Access Compliance Report

Public Rights-of-Way

(Curb Ramps)

Intersection ID: 15116	Main Street: EUCLID_AV	Cross Street: IDEAL_WY	Location: E
ADA ID: 07D09C833FAB	Ramp Type: Perp	Initial Pass/Fail: Fail	Overall Compliance: No
			Severity Score: 13.75

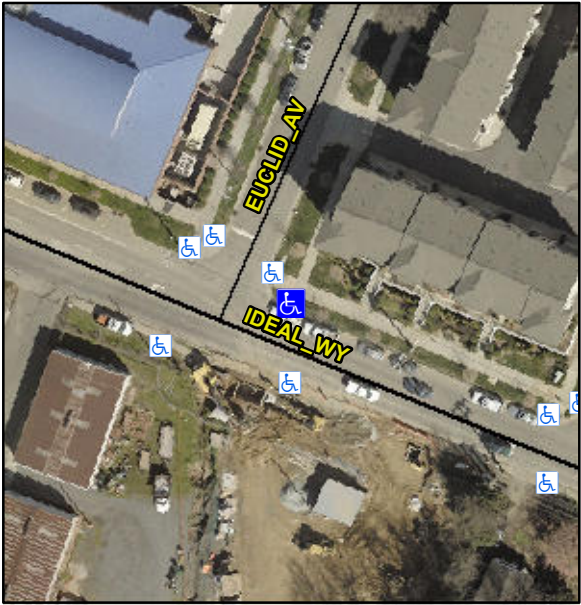
Codes/Mitigation Info/Possible Solution			Field Measurements/Component Compliance		
	Possible Solutions:		Compliance	Description	Data
	Remove & Replace Entire Ramp.		N/A	Ramp Length (in)	98.0
			Yes	Ramp Width (in)	65.0
			N/A	Flare Type LT	N/A
			N/A	Flare Slope LT (%)	N/A
			N/A	Flare Traversable LT?	N/A
			N/A	Landing Length (in)	N/A
			N/A	Landing Width (in)	N/A
			N/A	Landing Slope (%)	N/A
			N/A	Landing X Slope (%)	N/A
<p>Surveyor Notes:</p> <p>N/A</p> <p>PROW/ADA:</p> <p>R304.2.2, R304.5.3</p>			N/A	Flare Type RT	N/A
			N/A	Flare Slope RT (%)	N/A
			N/A	Flare Traversable RT?	N/A
			N/A	DWS Provided?	N/A
			N/A	DWS Contrast?	N/A
			N/A	DWS Length (in)	N/A
			N/A	DWS Full Width?	N/A
			N/A	DWS Offset (in)	N/A
			N/A	Shared Landing?	N/A
			N/A	Gutter Ponding?	N/A
			N/A	Gutter Lip Ht (in)	N/A
			N/A	Painted X Walk1?	No
				X Walk 1 Direction	To SW
			N/A	X Walk 1 Width (in)	N/A
				X Walk 1 Slope (%)	2.9
				X Walk 1 X Slope (%)	1.8

N/A	Ramp inside XWalk1?	N/A
				Road Slope (%)	N/A
				Road X Slope (%)	N/A
			N/A	Any Obstructions?	N/A
				Obstruction Type	
Total Cost:		\$ 1850.00			
			N/A		N/A
			Yes	Surface Condition? (G/P)	Good
